Harrison/Police Station & Court Building – Design Guidance Review Meeting
Project Manager: Kelly Tayara & Ellen Fairleigh

Vincent Road Transfer Station – Conceptual Proposal Review Meeting
Project Manager: Kelly Tayara

Winslow Hotel (PLN50880 SPR CUP) – DRB Review & Recommendation Meeting

**CITY OF BAINBRIDGE ISLAND
DESIGN REVIEW BOARD – REGULAR MEETING
June 3, 2019**

WINSLOW HOTEL
Cutler Anderson Architects

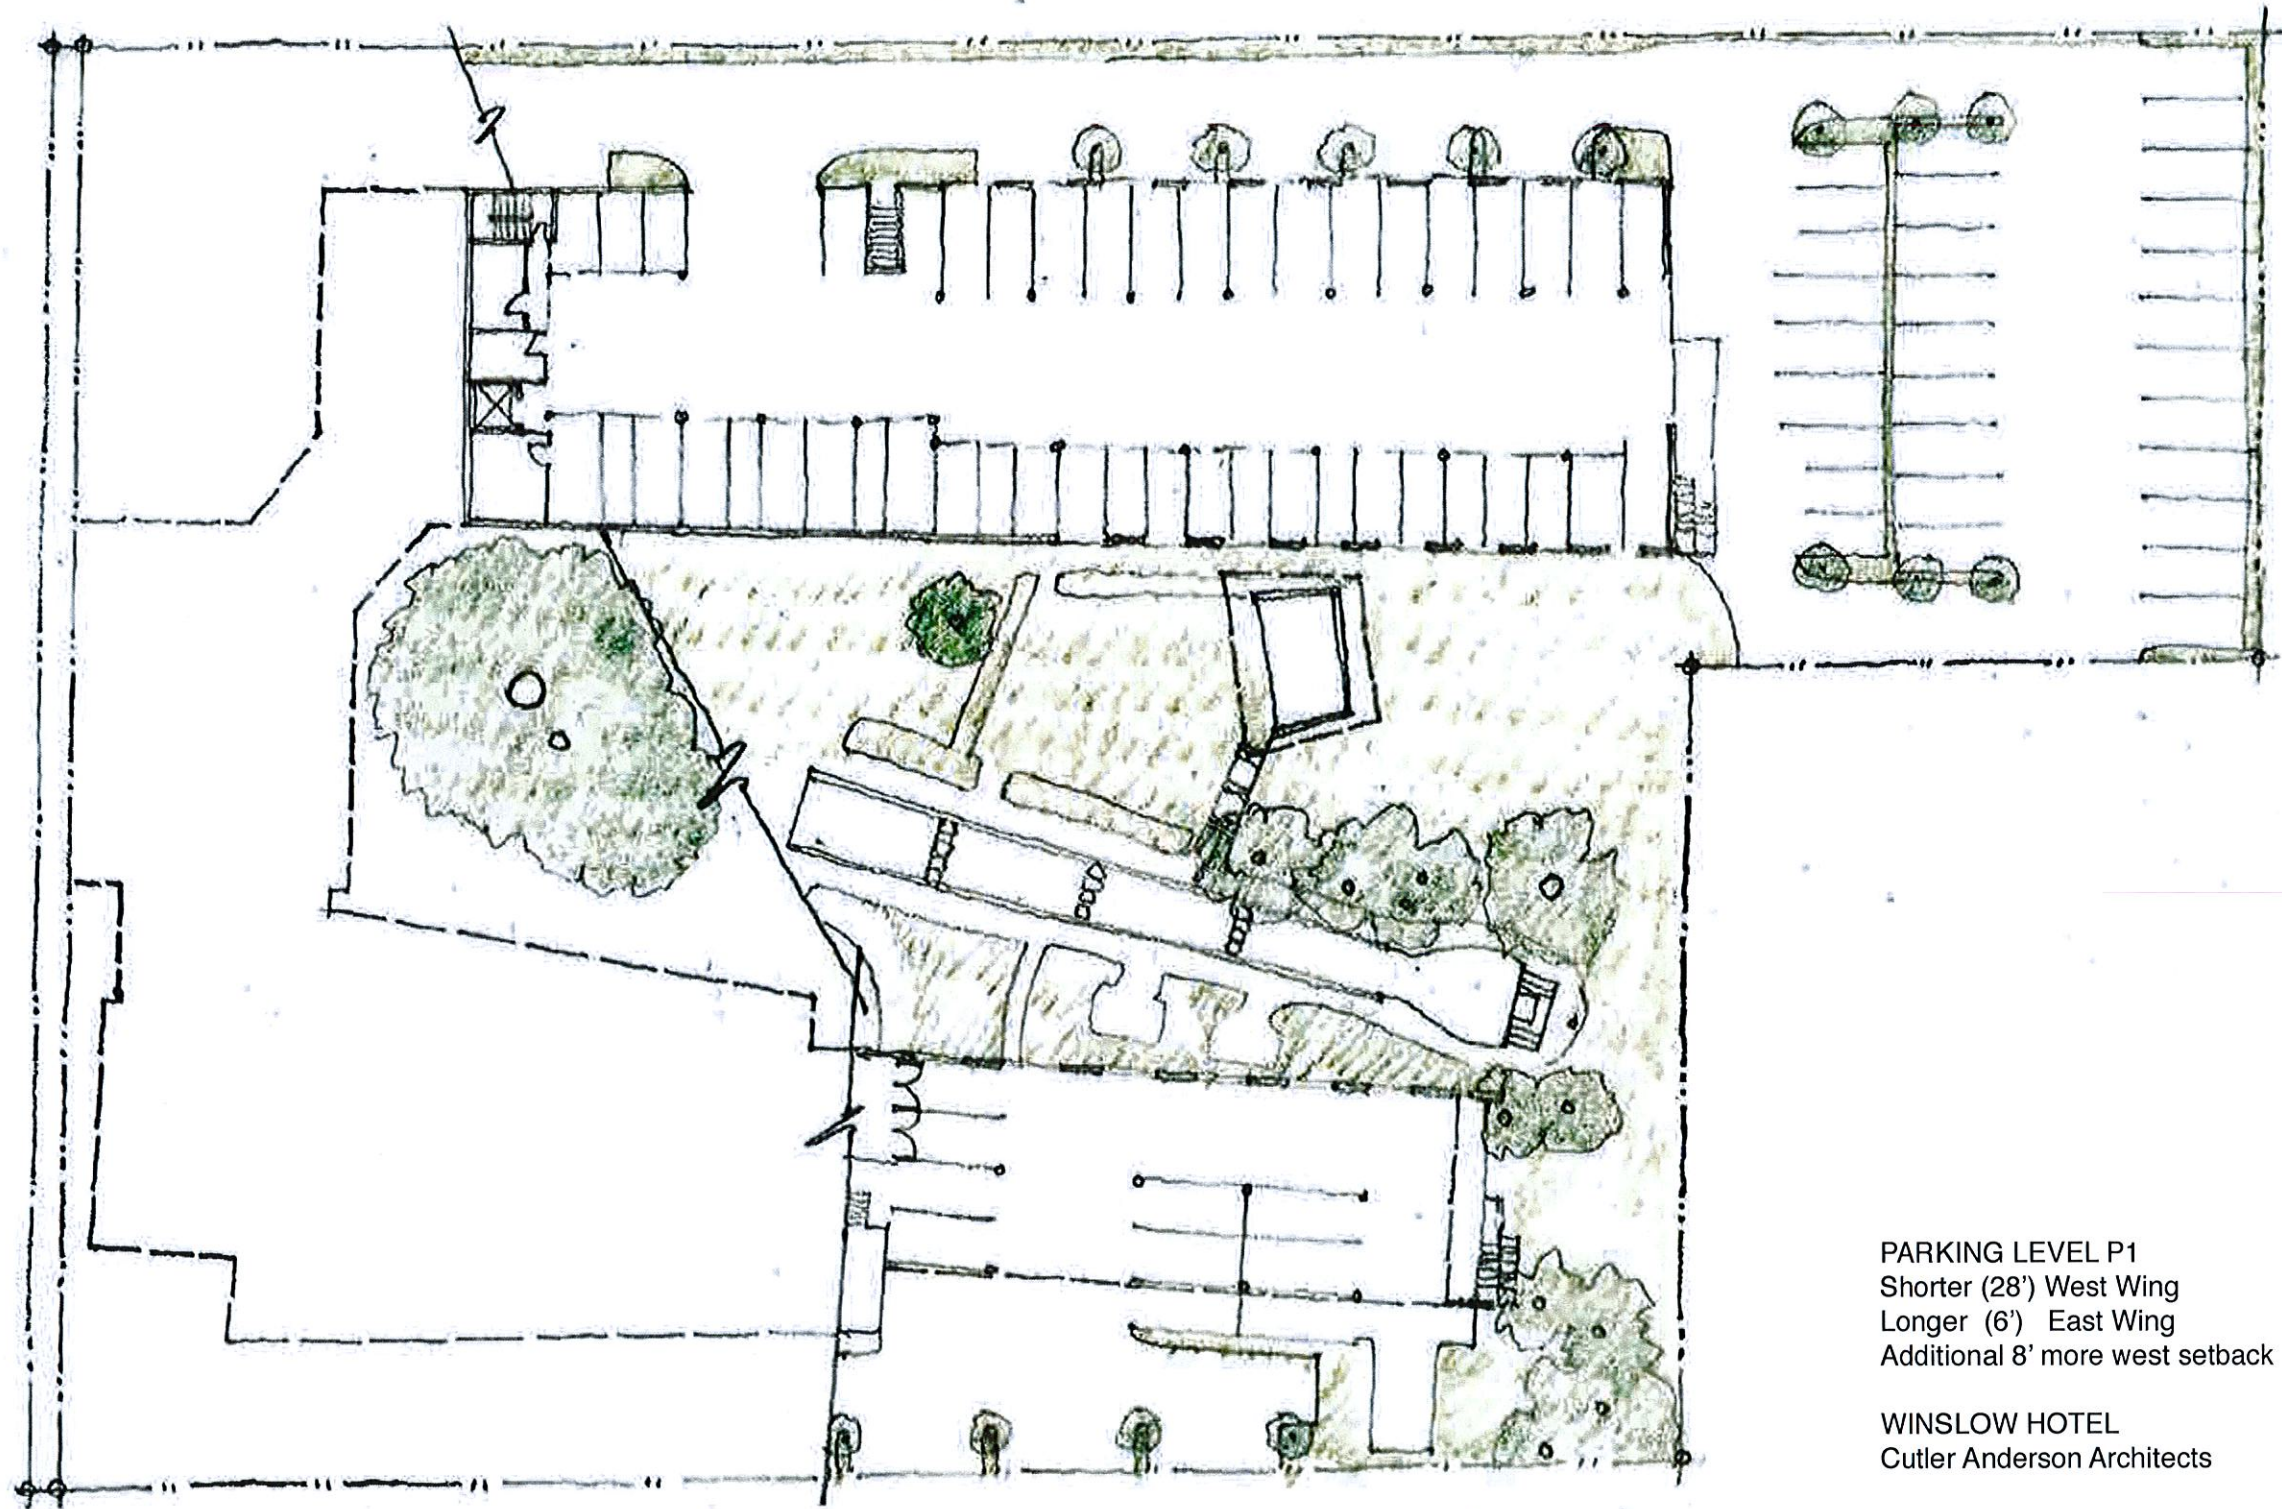
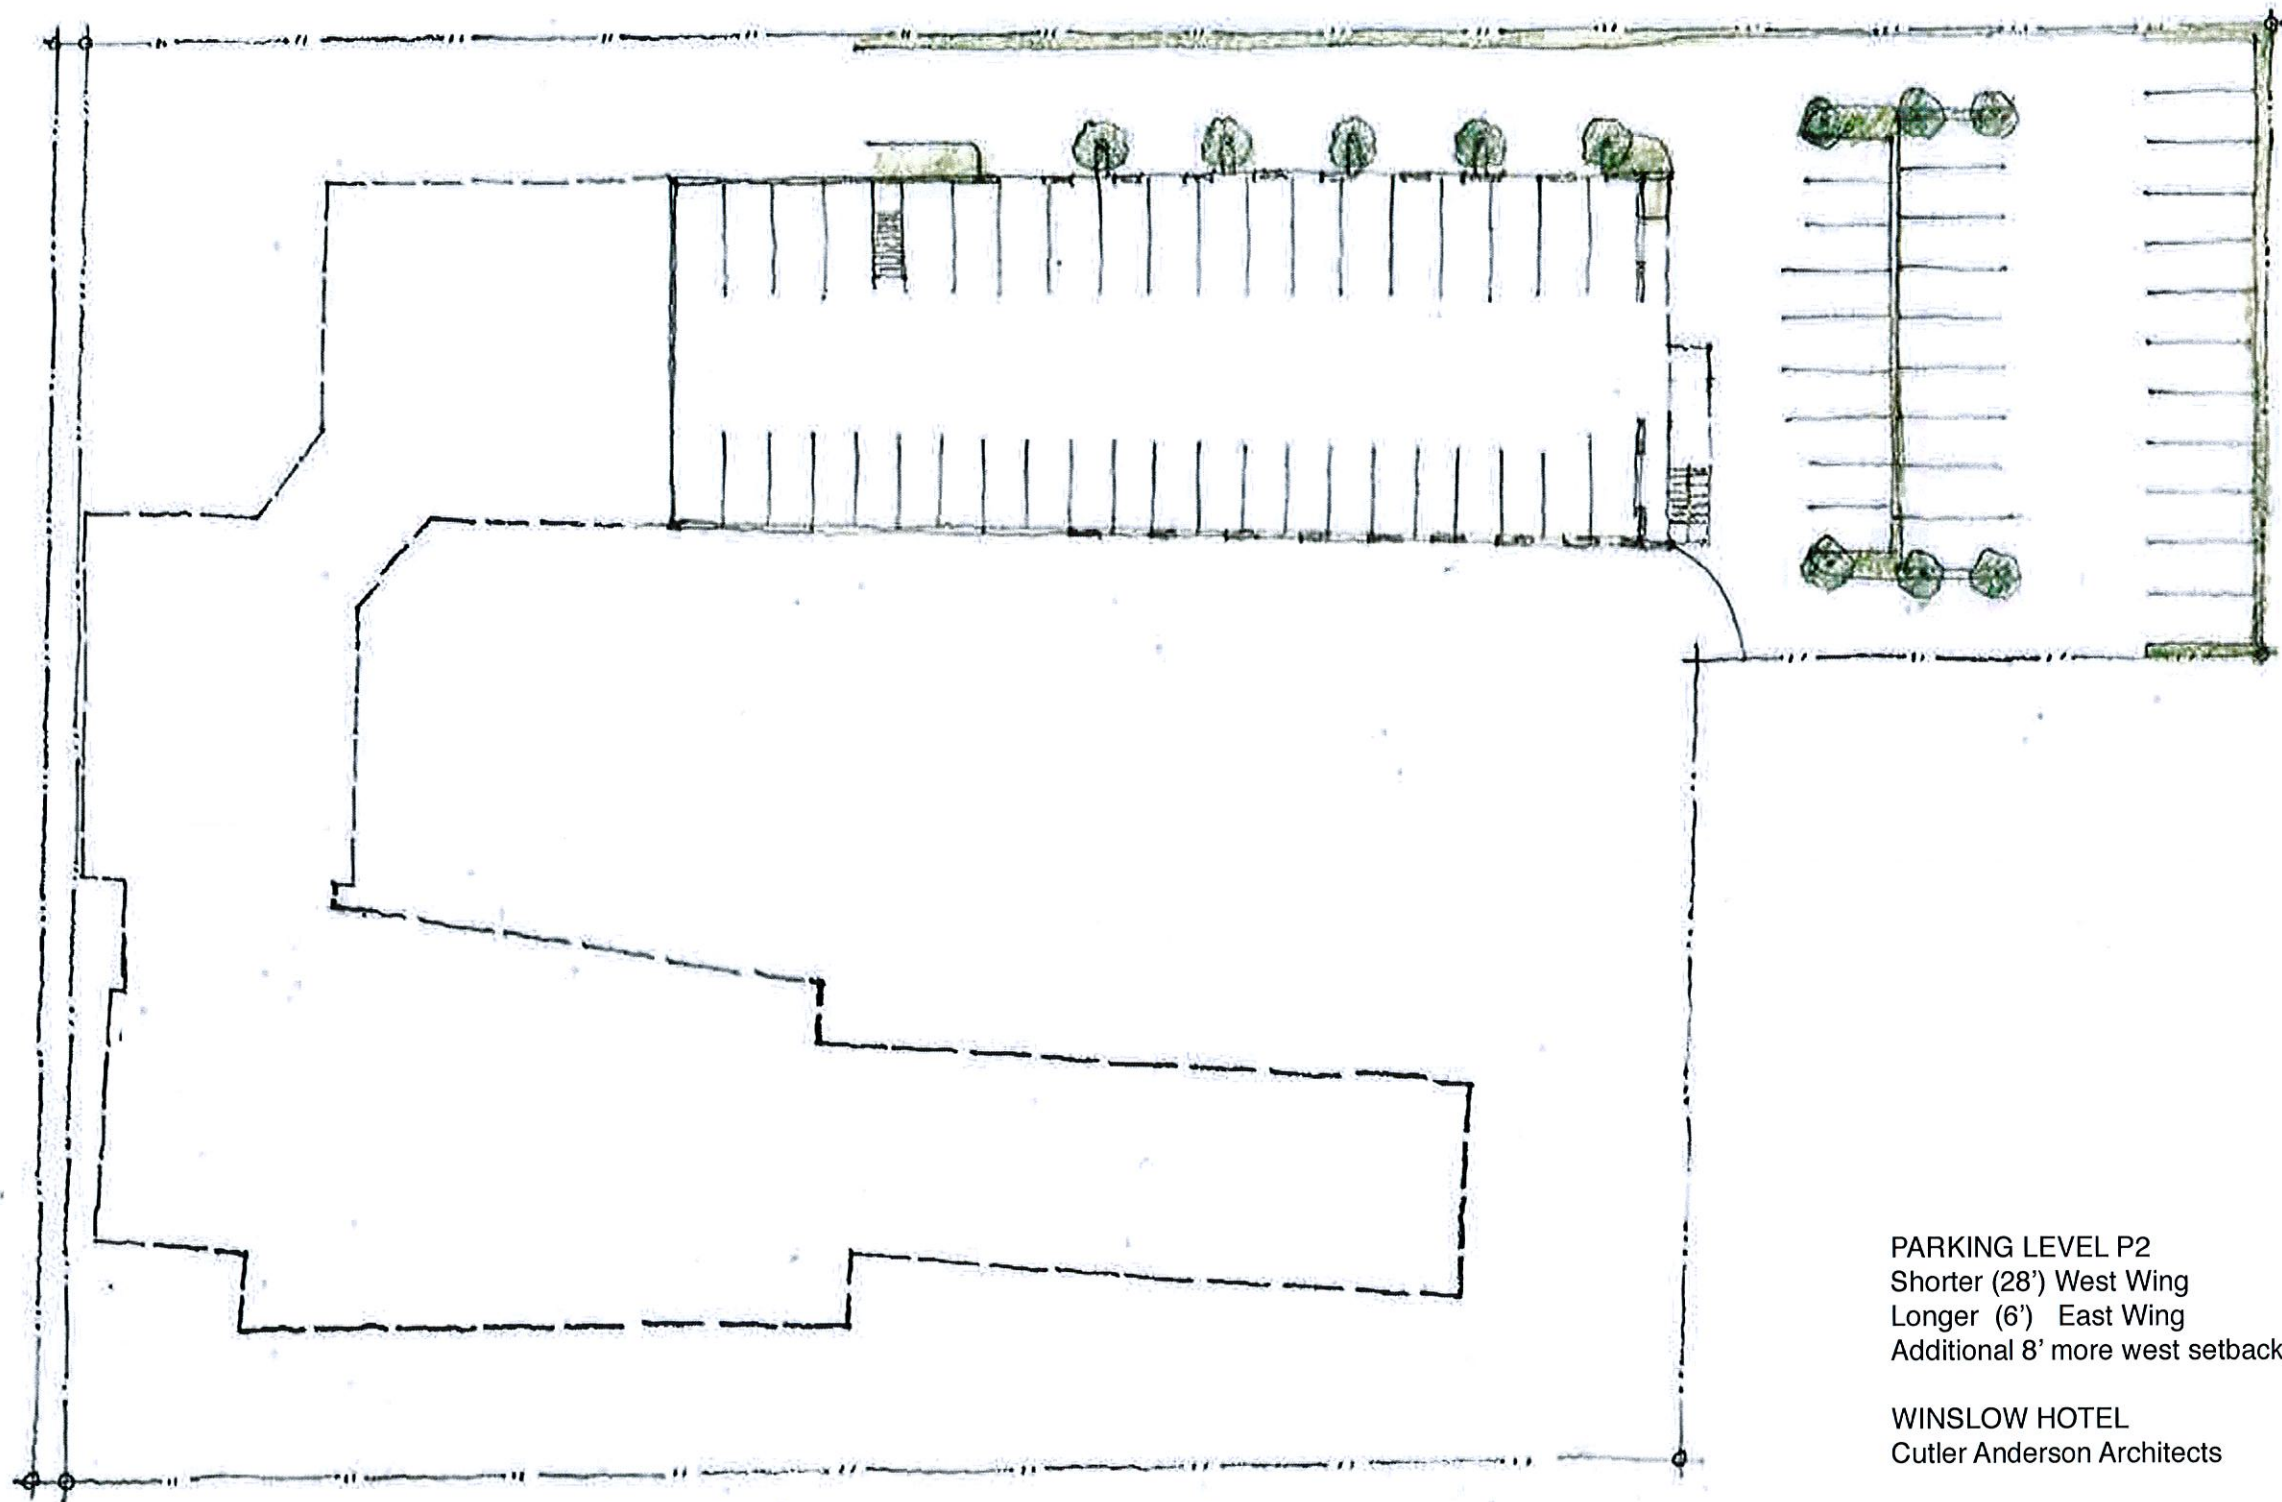
Review & Recommendation of Option 2 -

Motion: I recommend approval to move entire west wing of the façade 8 feet to the east and the addition of six parking spaces plus additional landscaping.

Dunstan/No 2nd: Passed unanimously
